**TOWN OF MOUNTAIN VILLAGE  
DESIGN REVIEW BOARD REGULAR MEETING  
WEDNESDAY MARCH 30, 2016 10:00 AM  
2nd FLOOR CONFERENCE ROOM, MOUNTAIN VILLAGE TOWN HALL  
455 MOUNTAIN VILLAGE BLVD, MOUNTAIN VILLAGE, COLORADO  
AGENDA**

**TO:** Design Review Board  
**FROM:** Colleen Henderson, Planner II  
**FOR:** Meeting of March 30, 2016  
**DATE:** March 24, 2016  
**RE:** Conceptual Work Session for a New Single-Family Residence on Lot AR-32

**Application Overview:** The purpose of this agenda item is to allow the Design Review Board (DRB) to provide initial direction to the applicants regarding a proposed new single family home.

Exhibit WS-4  
Window Recess Detail

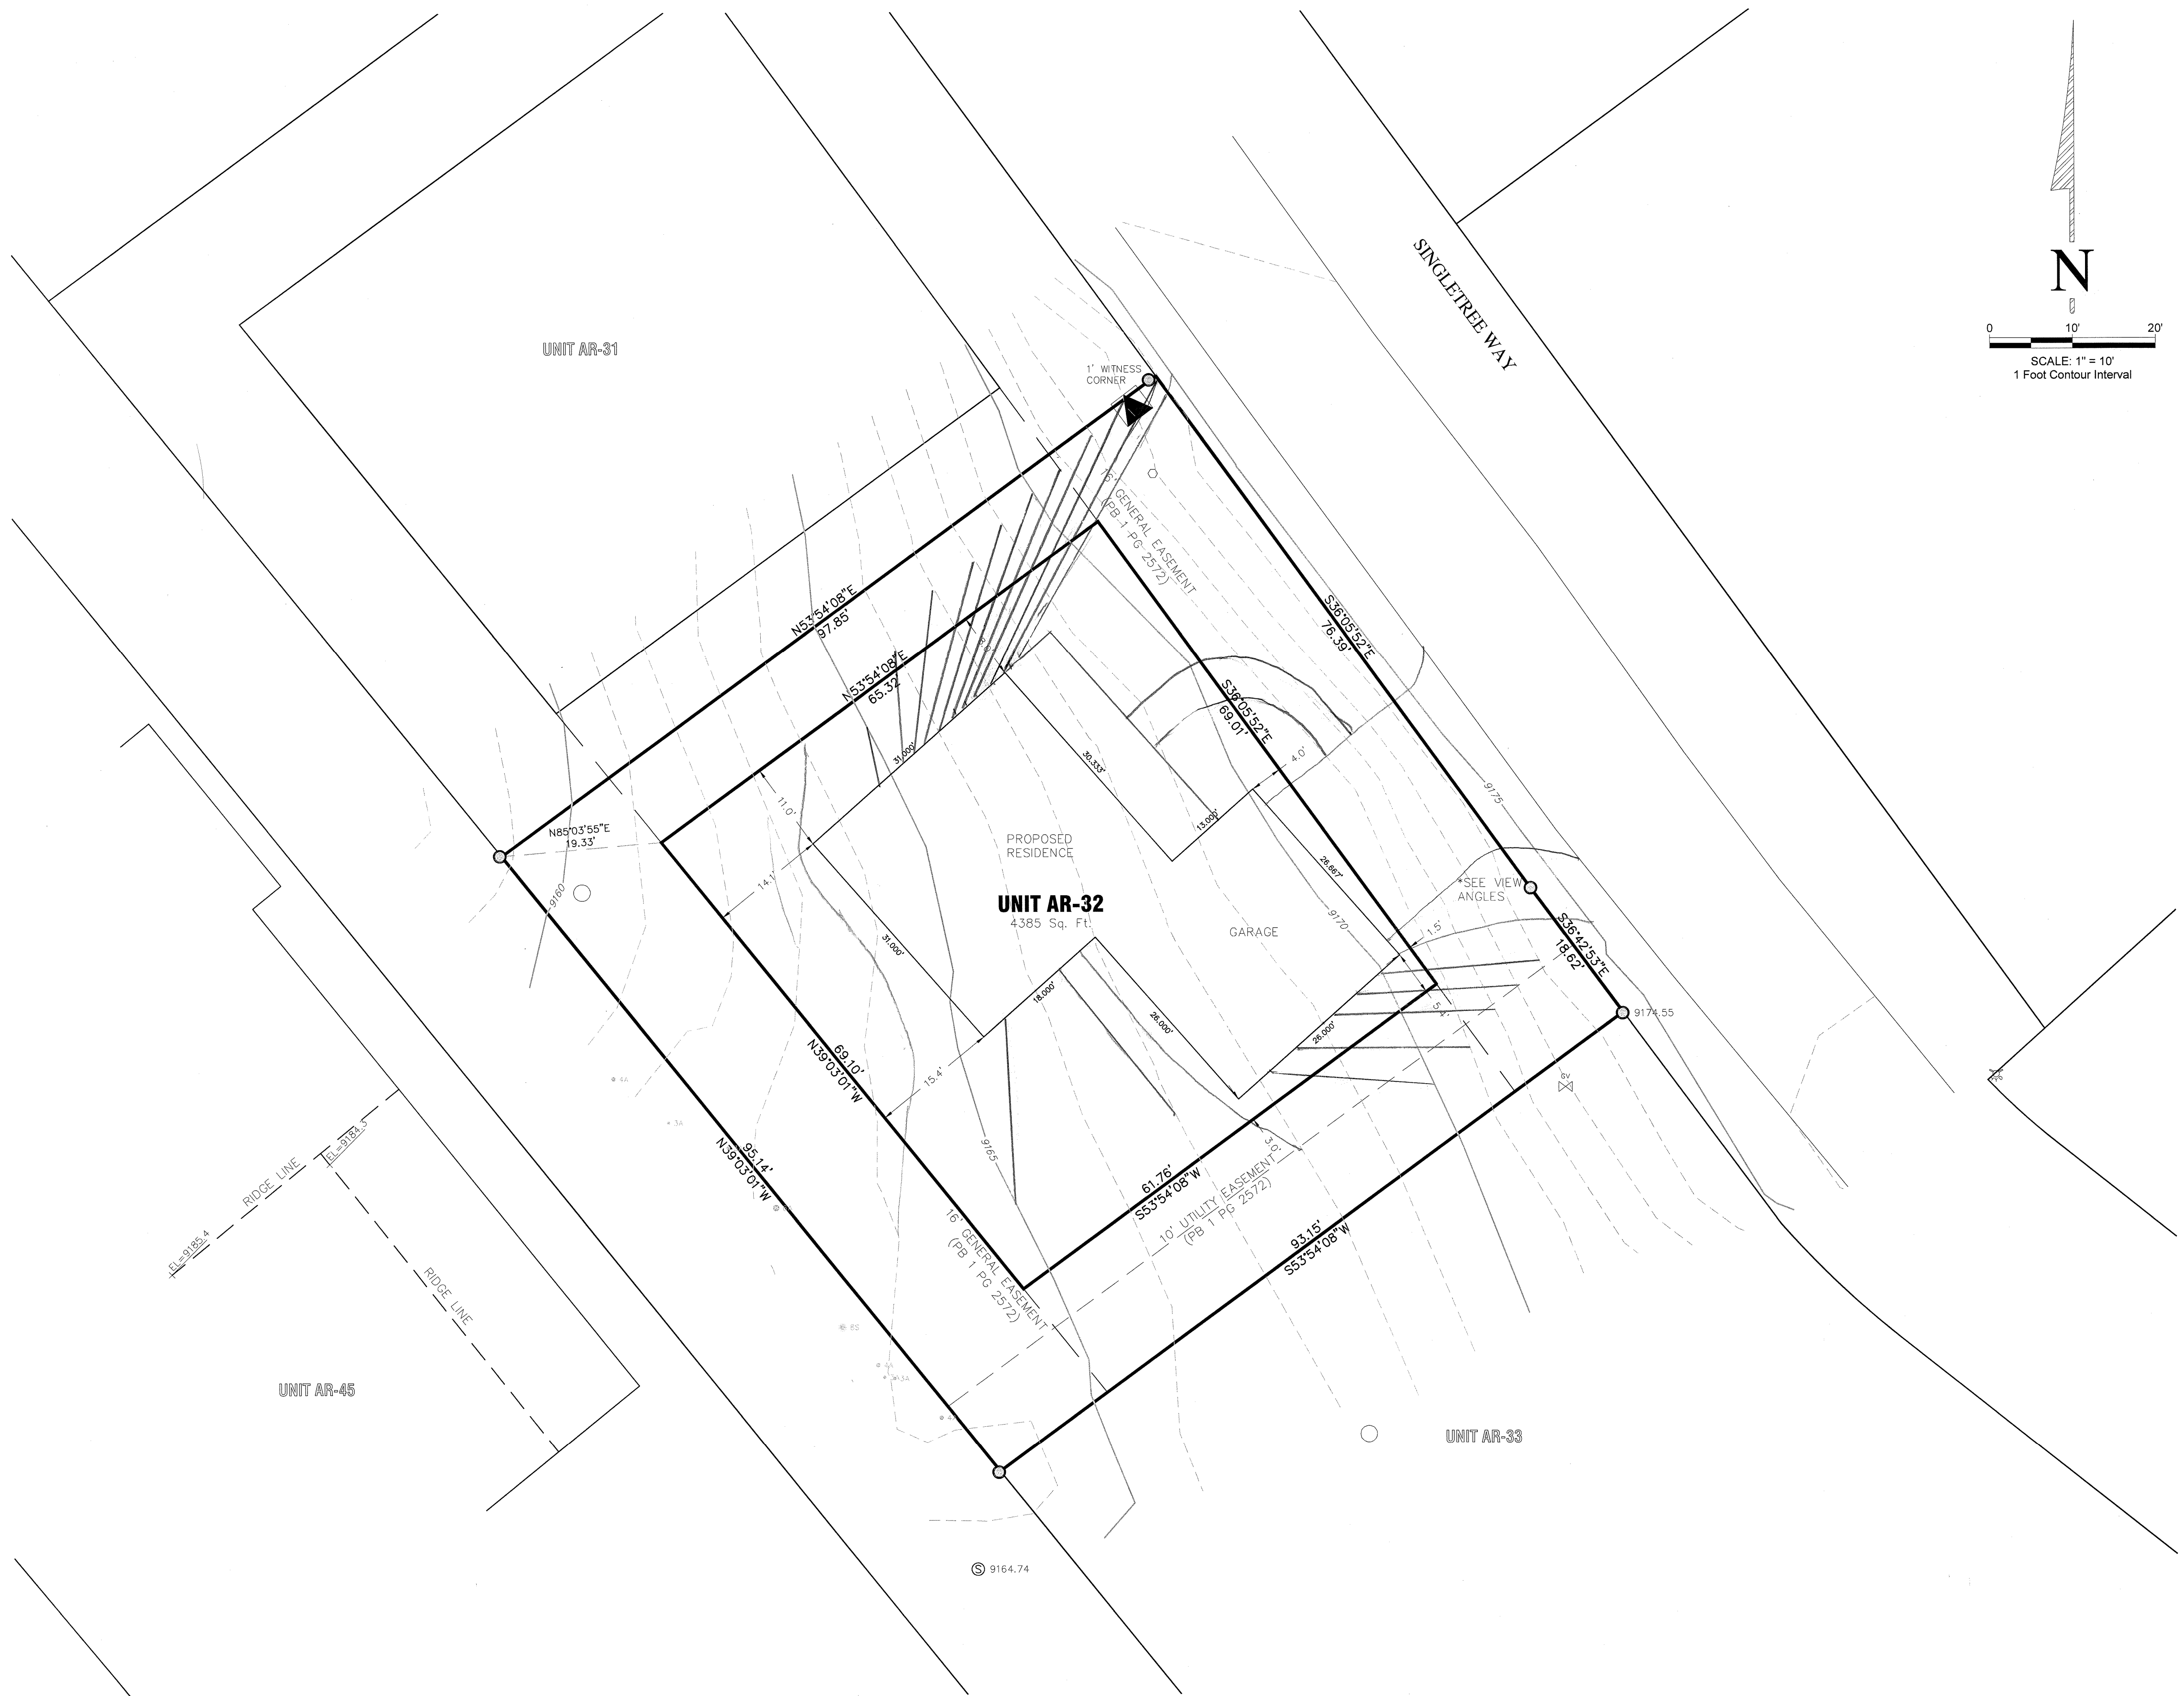
All window frames and trim are specified as clad aluminum and appear to meet CDC standards. Windows and doors will be recessed back from the face of the exterior material by the required minimum of five inches (5"). Future staff review will verify the maximum window area requirement of forty percent (40%) of the total building façade. The material of the primary entrance door has not been specified. The garage doors are indicated as metal sectional overhead doors with barn wood accents as shown in Attachment A (Exhibit 17-Sheet 2). All entries and doors appear to be protected from snow and ice shedding. Staff recommends establishing additional interest, variety and character to the front entryway.

# Exhibit WS-10 Exterior Lighting Plan (Sheet 2 of 3)

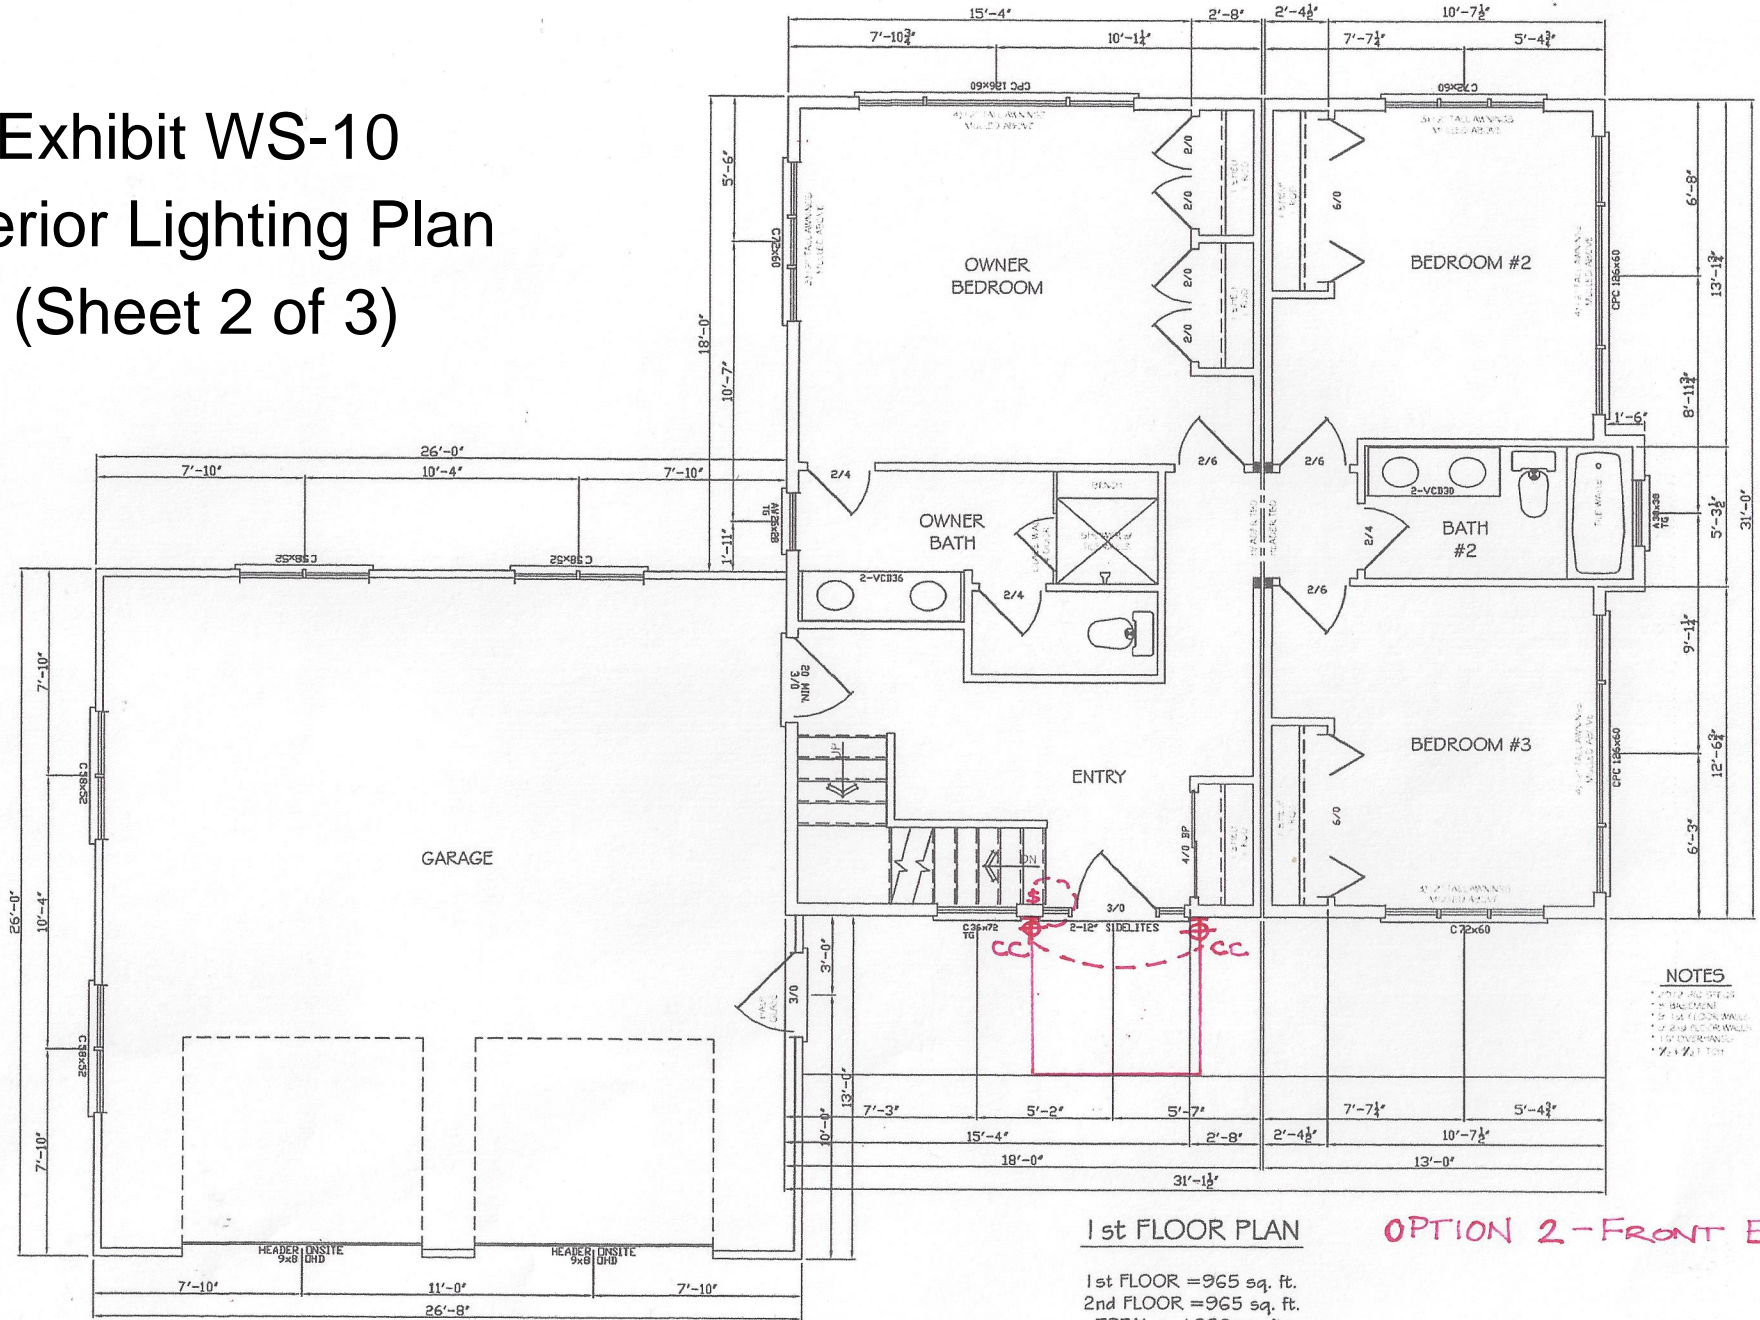
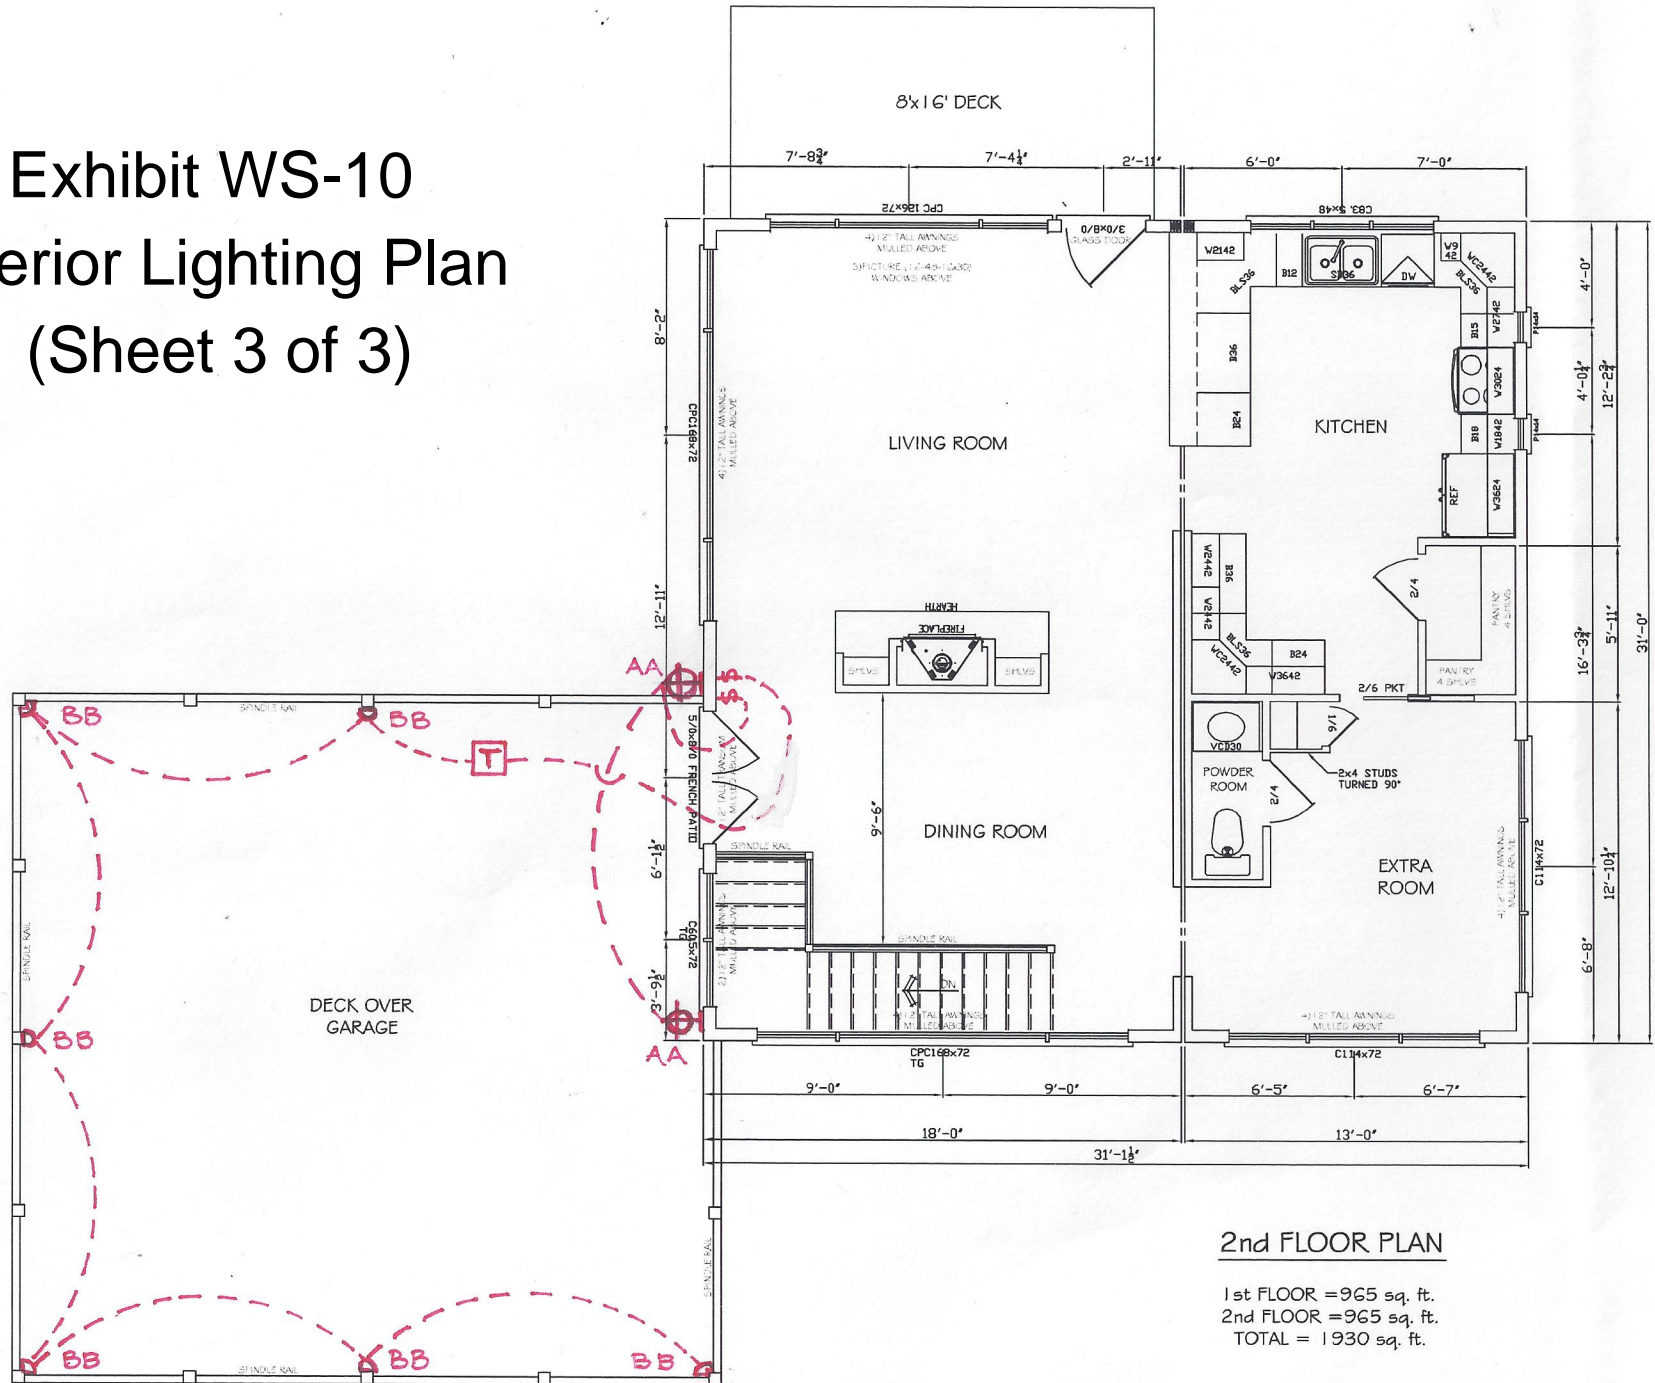
The preliminary lighting plan provided in Attachment A (Exhibit WS-10) includes the use of nine (9) sconces and six (6) deck post lights. Sconce locations include doors, deck area, garage entrance, and address monument. Following the guidelines for exterior lighting, Exhibits WS-11 through WS-16 (Attachment A) indicate the proposed lighting is subdued, understated and indirect to minimize impacts to surrounding neighbors. All exterior lighting includes full cut-off fixtures that direct the light downward without any off-site glare. LED lighting or other equivalent energy saving lighting will be used for all exterior lighting. Down lighting is shown on some of the posts on the garage roof deck railing. It is noted that the applicants are considering two options for lighting above the front door and would appreciate feedback from the DRB.

The proposed lighting plan (Exhibit WS-10) includes nine sconces and six (6) deck post lights; the applicant will also discuss a possible alternative for lights at the front door. Sconce locations include doors, deck area, garage entrance, and address monument. All lighting has been designed as full cut-off fixtures (Exhibits WS-11 through 16) with LED bulbs at CDC allowable Kelvin temperature.
